MPE720 improvement item and bug fix change

Items added and features improved from MPE720 version 5.38 to version 5.39 are as follows.

No.2 Support to MNET-01 module

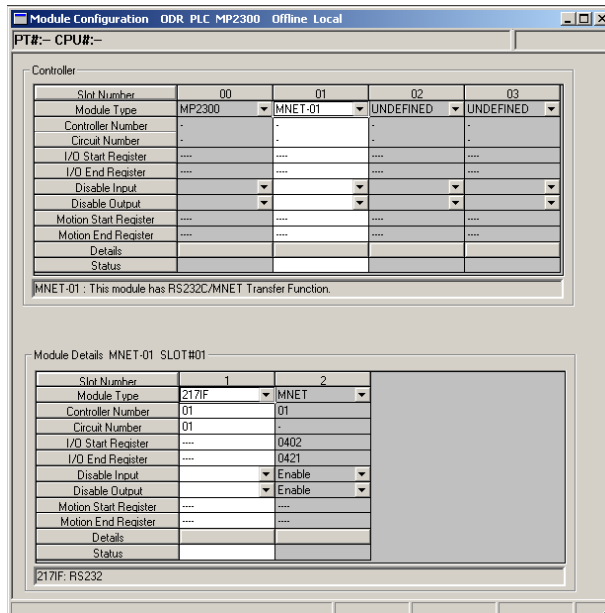
It supported to the MNET-01 module that was the new option module. The MNET-01 module has the function of 217IF and MNET.

*: This module can be used since MP2000 system software version 2.61.

No.3 Improvement of application converter

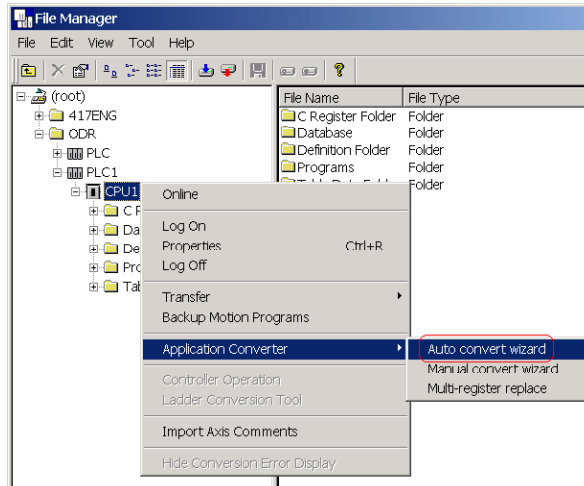
The conversion specification of a current application converter is reviewed to do the application conversion into MP900->MP2000 easily, and the function has been improved.

- The auto convert function of the module was supported.

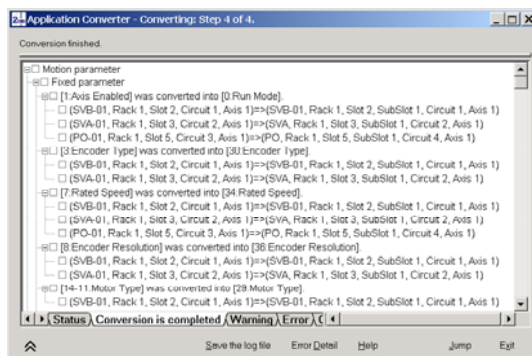
- The conversion rule of the parameter was reviewed.

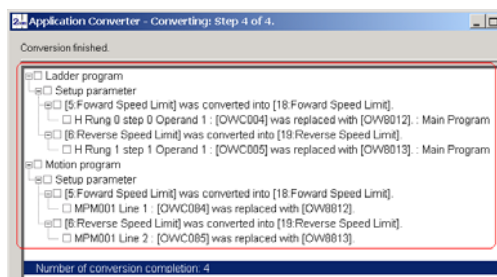
- The display format of the log was changed (support of the tree view).

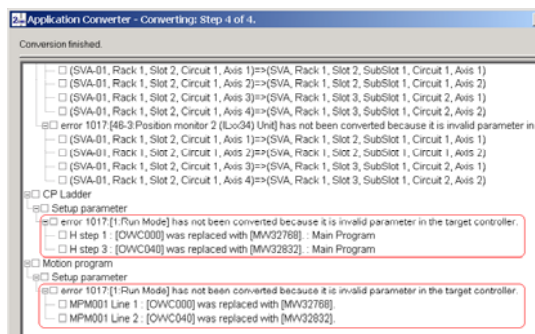
-: The register that was not able to be converted was converted into an unused M register area with MP900.

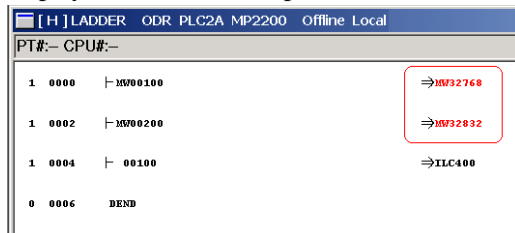
- After it had converted it, the register for which the replacement was necessary made the conversion part display in red-letter, and specified.

No.4 Scoping expand print of new ladder (improvement).

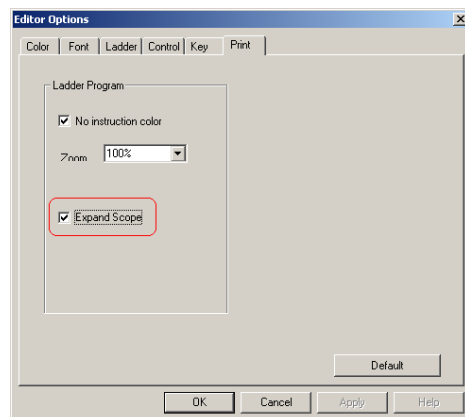
The new ladder program was able to be printed with Scoping ON.

No.5 Support to D register of Multi-register replace (improvement)

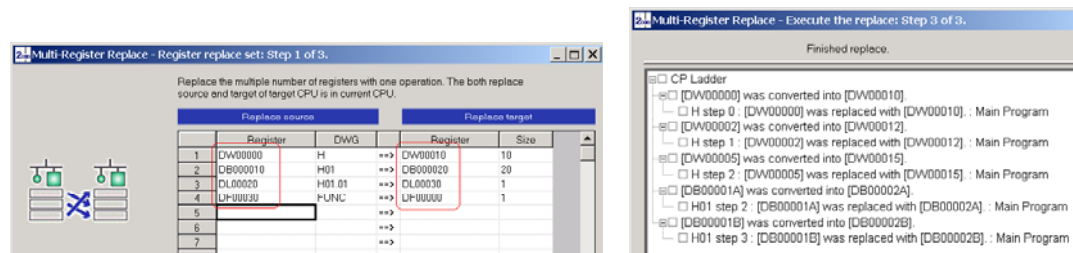
To replace D register of DWG, "Multi-register replace" function has been improved.

No.7 Support to user constant Pn0000 of SJDE-**AN*

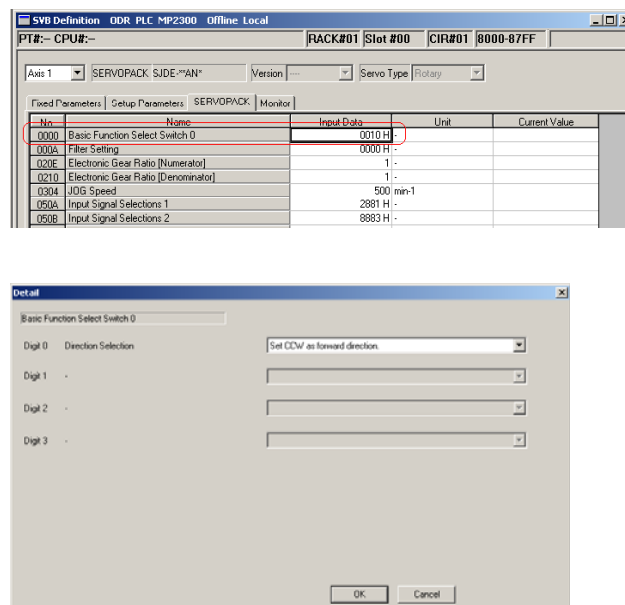
User constant Pn0000 of SJDE-**AN* was made a parameter that was able to be operated.

No.9 Communication process GW function connection trouble

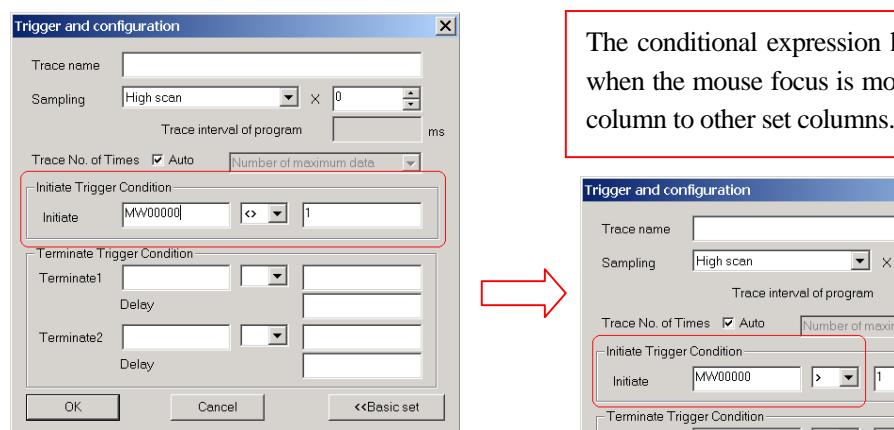
There was a thing that the communication froze when the machine with a good spec was connected with MP2500 in the environment with which GW was connected. Therefore, this was corrected.

No.12 Servo pack details menu operation trouble

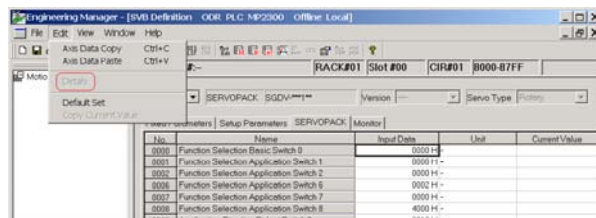
"Details" in the edit menu of the servo pack parameter screen did not operate correctly. Therefore, this was corrected.

No.14 Saving trouble of setup parameter of MP930

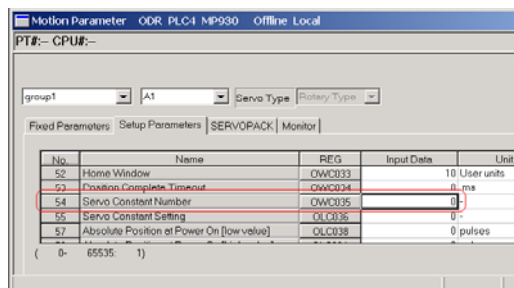
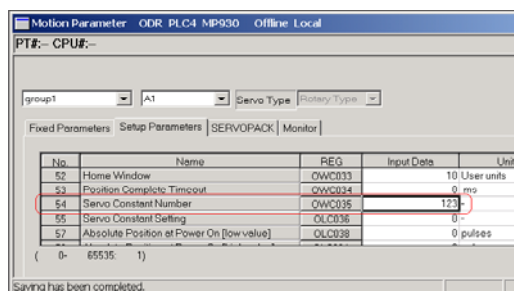
When the value of setup parameter No54 was input and saved on the motion parameter screen of MP930, it seemed to have completed saving normally. However, it returned to the value before it saved it when the tab was switched, and the value was not saved. Therefore, this was corrected.

It returns to the value before it saves it when the tab is switched.

No.15 Detailed screen display trouble of CNTR-01 module

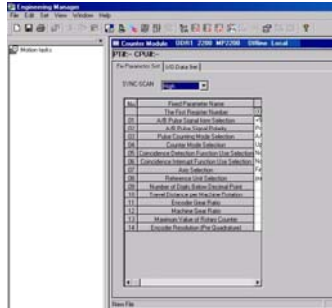
The detailed definition screen was interrupted in the blank part when a task manager and a quick watch were opened when a detailed screen of the CNTR-01 module was opened, and a set column was not seen occasionally. Therefore, this was corrected.
